Q. What is the CTX 300 CO2 Series 4 IR (S4IR)?

CTX 300

FAQ

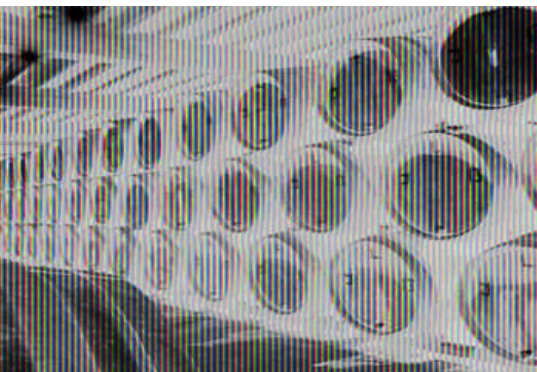
A. Without opening the box, it's easy to find out whether you have an old CTX 300 S4IR model (before July 2015). The gas intakes into the sensors are completely different on the two model (as shown in the image below).

Additionally the box reference number (P/N) printed on the ID label will be different depending on the model.

CTX 300 CO2 detector
(before July 2015)

P/N: 6514880
P/N: 6514881
P/N: 6514882

CTX 300 CO2 S4IR detector
(after July 2015)

P/N: 6314124
